Proposed Littles Subdivision Littles Road - Queenstown

REVISED SUBDIVISION LAYOUT - EARTHWORKS ASSESSMENT

WAKATIPU INVESTMENTS LTD - RM190656

RESPONSE TO QLDC REQUEST FOR FURTHER INFORMATION

ACCESS 1 LONGITUDINAL SECTION

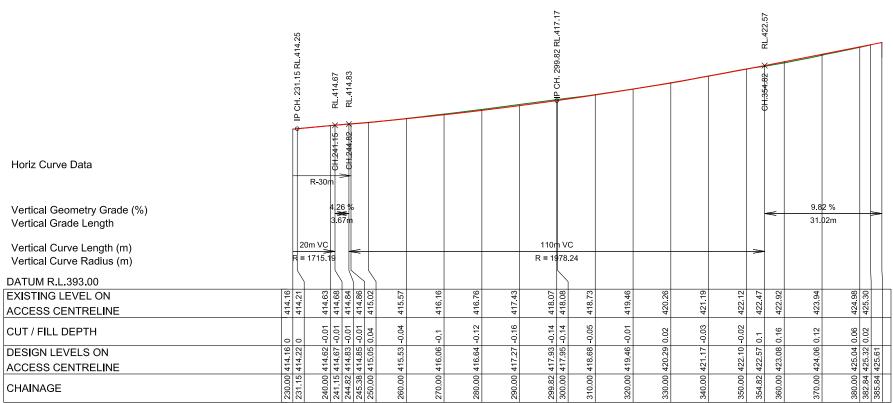
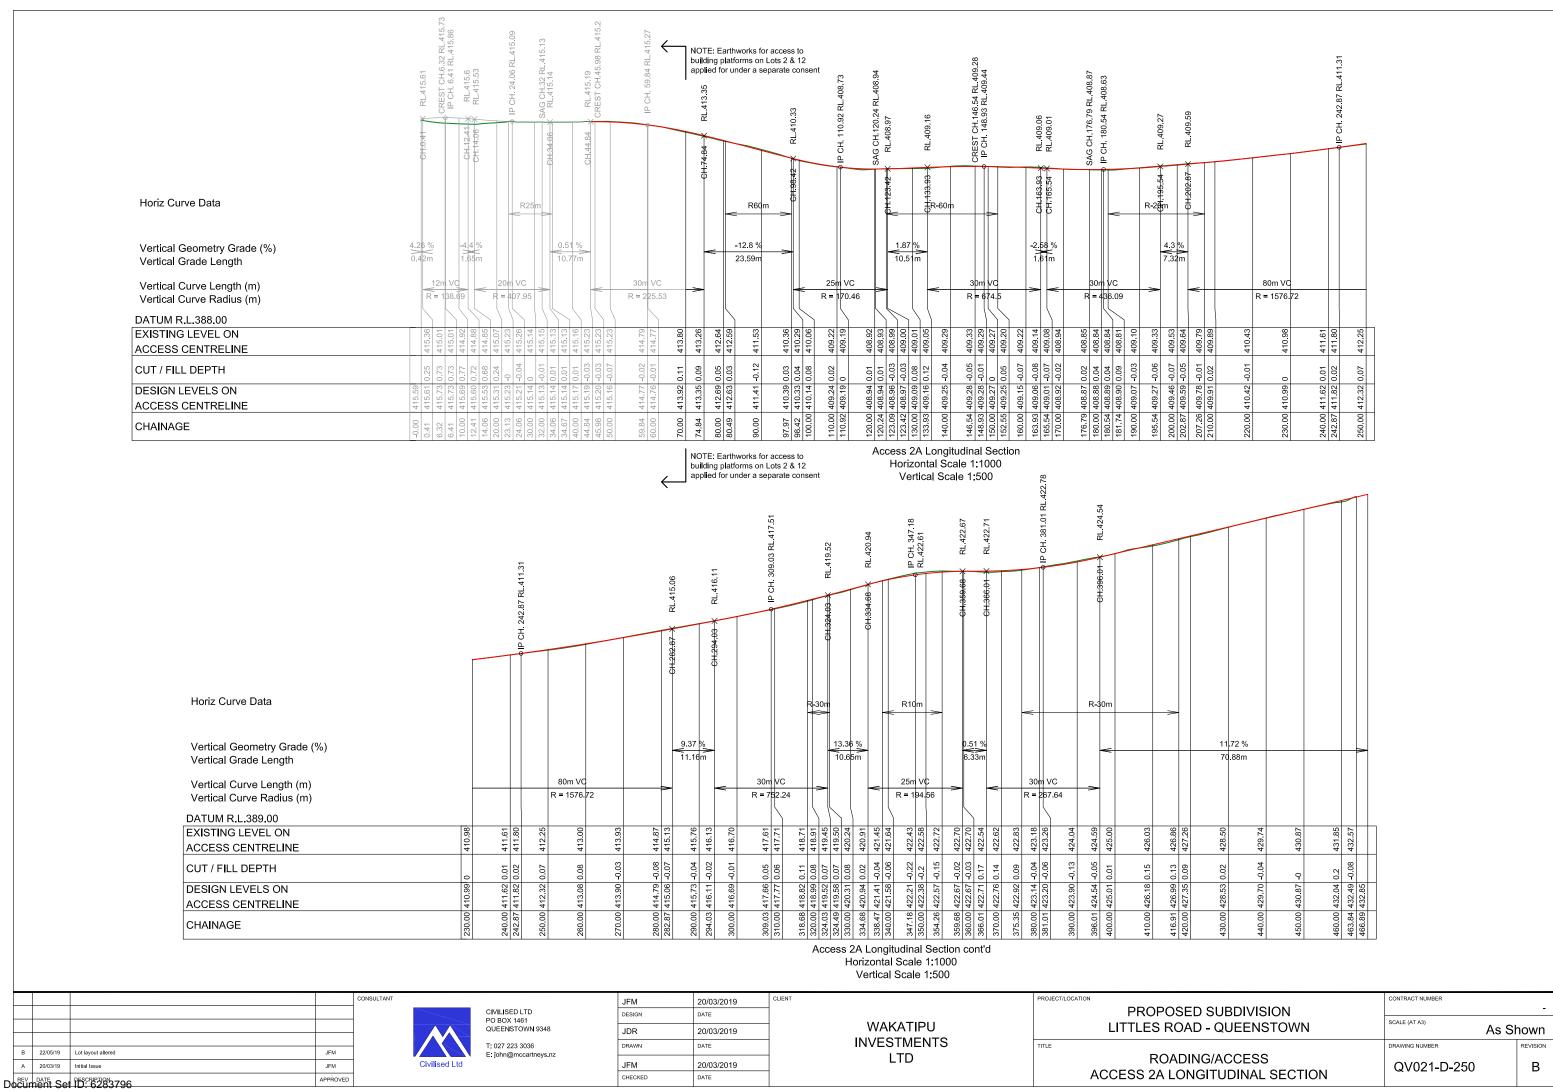
The infrastructure report by Civilised Ltd, dated 23 May 2019 indicates that Access road 1 (Ch0 – Ch160), Access road 2 (Ch0 – Ch170) and Access road 2A (Ch0-CH145) will be formed to E1 design standards (suitable to service 1-6 dwelling units) however more than 6 dwelling units are capable of being serviced along these sections of road, please amend to a recommended design standard to a standard capable of servicing 1-20 dwelling units.

The infrastructure report by Civilised Ltd, dated 23 May 2019 refers to "Access 1A", please provide plan which details where this access road is located.

In addition, the earthworks drawings have been updated. This includes correctly labelling the road width changes on Access 1. The updated drawings are attached to this letter as Attachment 1.
